# Water Right Conditions Tracking Slip

FILE # # G-17056

**PUBLIC INTEREST REVIEW FOR GROUND WATER APPLICATIONS**

TO: Water Rights Section Date August 6, 2008  
 FROM: Ground Water/Hydrology Section Josh Hackett  
 Reviewer's Name  
 SUBJECT: Application G- 17056 Supersedes review of \_\_\_\_\_  
 Date of Review(s)

**Water Levels in Nearby Wells**

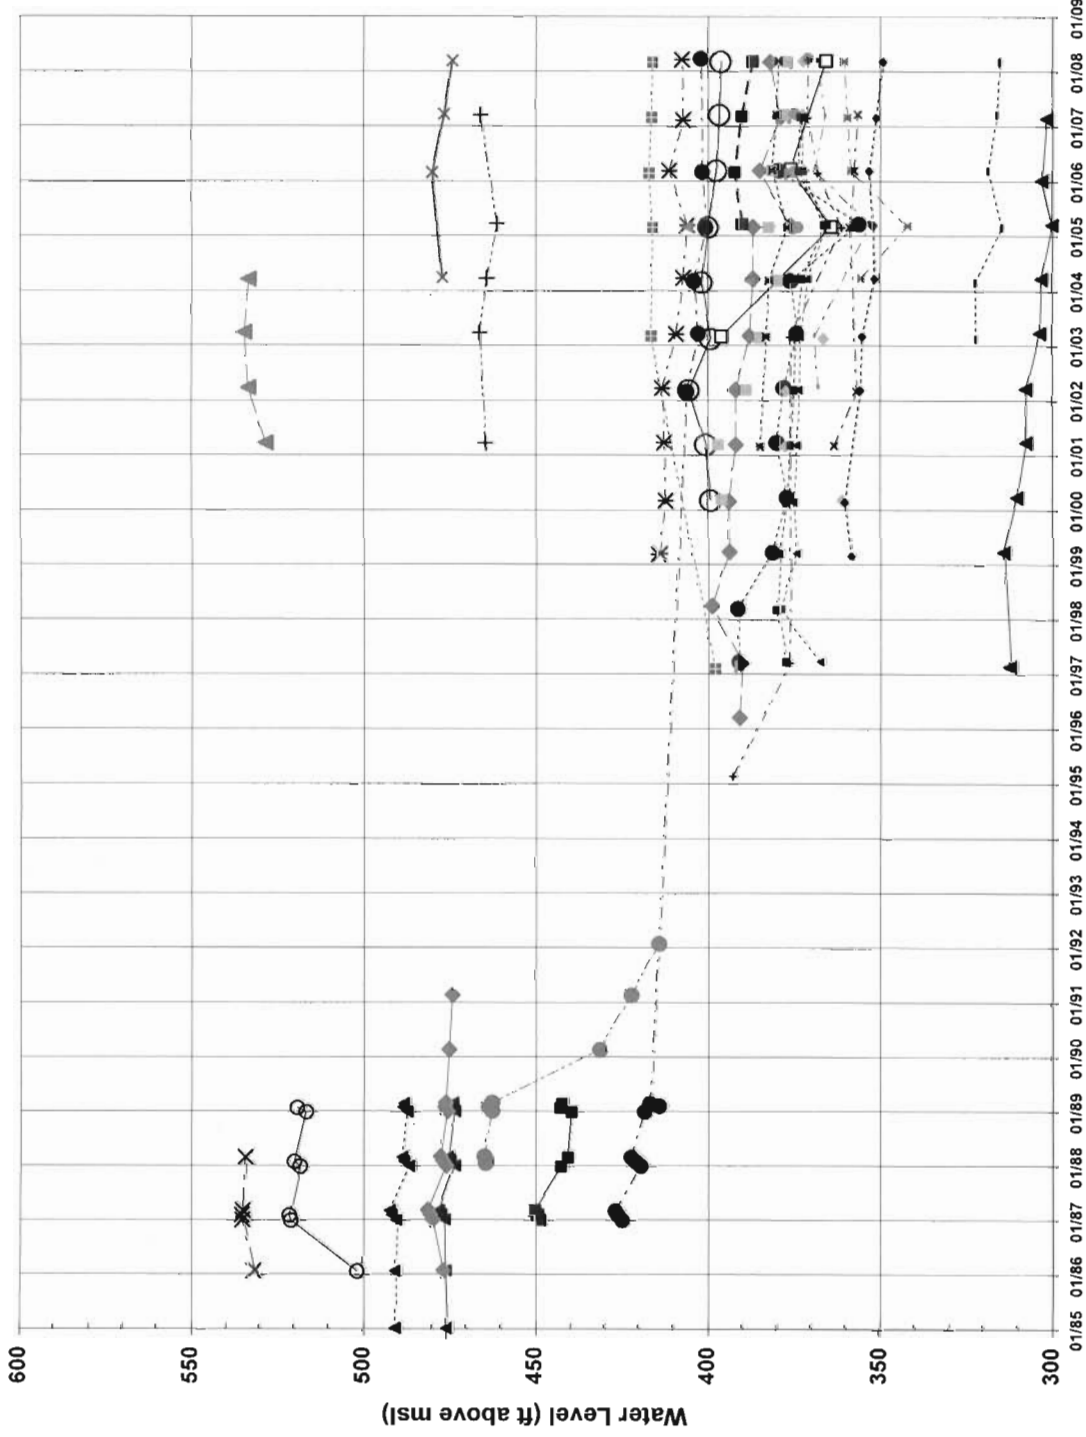
Water levels in the deep Troutdale aquifer are approximately 50-100 below the elevation of local stream reaches (see attached hydrograph).
